WAMBO COAL PTY LTD

NORTH WAMBO UNDERGROUND MINE LONGWALL 10A MODIFICATION

RESPONSE TO SUBMISSIONS

December 2014

Figure A6. Model Column 232: (a) Hydraulic Conductivity Host Zones and Permanent Fractured Zones; (b) Dynamic Fractured Zones

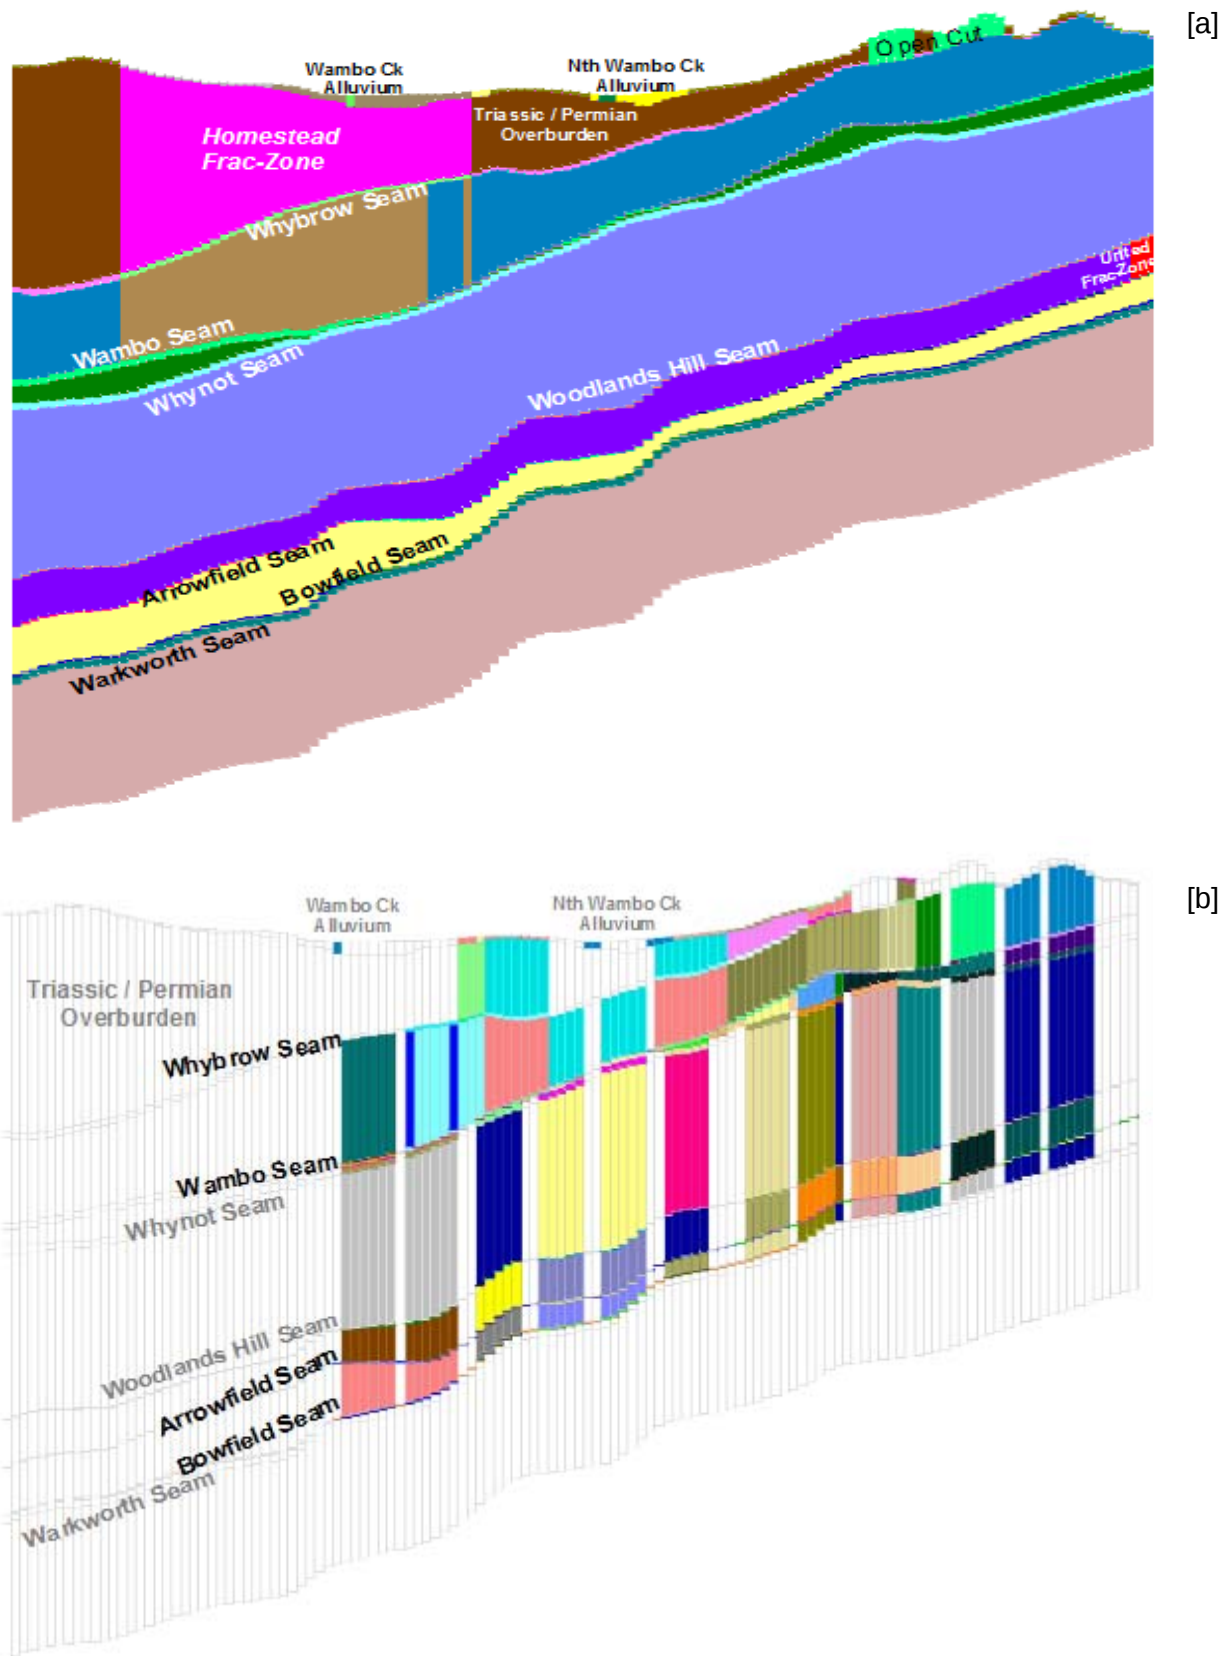
Comment	Response
Department of Primary Industries (DPI) (Including NSW Office of Water [NOW]) The NOW stated that a cumulative assessment of the subsidence impacts from the proposed Longwall 10A and the <u>future approved extraction proposed in two underlying seams (Arrowfield and Bowfield Seams) had not been completed.</u> The NOW requested further detail on the fracturing heights from mining the Wambo Seam in Longwall 10A, in particular with respect to whether the proposed extraction was considered as a multi-seam extraction for the purpose of deriving fracture zone extent given the existing approval for the underlying Arrowfield and Bowfield Seams. The NOW requested a series of slices (diagrammatically) in both horizontal and lateral extent for the various model layers displaying how the fracturing heights and hydraulic conductivities have been applied.	
	The NOW's statement that cumulative assessment of the Arrowfield and Bowfield Seams was not considered in the Groundwater Assessment is incorrect. As stated on page 25 of the Groundwater Assessment (Appendix B of the EA): <i>The mine workings represented in the model include:</i> • <i>Homestead and Wollemi Underground (Wambo) (completed prior to steady state calibration period);</i> • <i>South Bates-Whybrow Seam Underground (Wambo);</i> • <i><u>Arrowfield and Bowfield Underground (Wambo);</u></i> ... As requested by the NOW, HydroSimulations has prepared five cross-section slices of the model with the locations of three east-west and two north-south lines shown in Figure A1 (Appendix A). These slices are provided in Figures A2 to A6. These figures show the extent of adopted fracturing in the groundwater model. The upper figure shows host (pre-mining) permeabilities and permanent fracture zones. The lower figure shows fractured zones that grow dynamically as the simulation of mining progresses in the model. Figures A2 to A6 confirm that the fracturing represented in the model is definitely conservative, as it has been assumed that all intervening interburden zones between mined coal seam pairs are fully fractured. Table 8 of the Groundwater Assessment (Appendix B of the EA) listed the permeabilities of fractured zones for the North Wambo, United and Homestead mines. Table A1 (Appendix A) provides the same information for the fractured zones applied in the model above the proposed Arrowfield and Bowfield workings. Therefore, the NOW's concerns as to the lack of consideration of connective cracking have been directly addressed.
